VALUE ENGINEERING REDESIGN OF WALL 2 PREPARED BY GEODESIGN, INC. 3-16-05

PROJECT NAME: SPRINGFIELD
PROJECT NUMBER: STP 016-2 (10)S

FILE NAME: 000d24\structures\ab024ve3.I
PROJECT MANAGER: W. FRANK
DESIGNED BY: M. HARIHARAN
PLOT DATE: 3-16-05
DRAWN BY: S. CATUCCIO
CHECKED BY: W. FRANK
SHEET 47A OF 72

WALL ELEVATION (3)

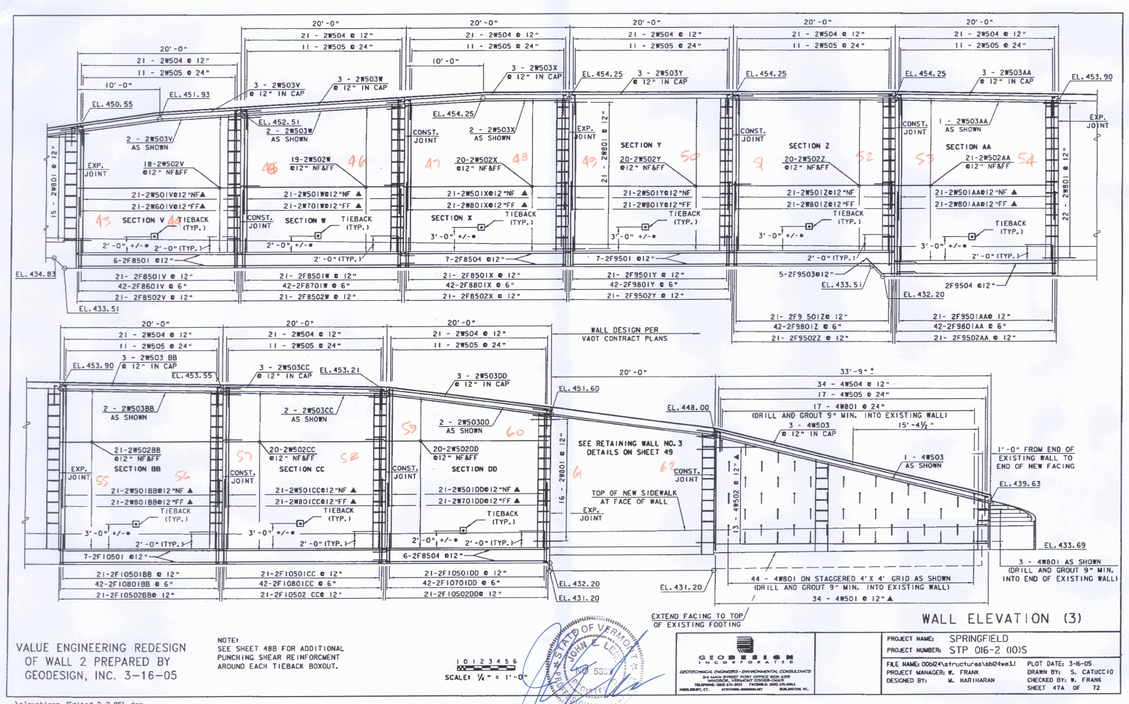
NOTE:
SEE SHEET 48B FOR ADDITIONAL PUNCHING SHEAR REINFORCMENT AROUND EACH TIEBACK BOXOUT.
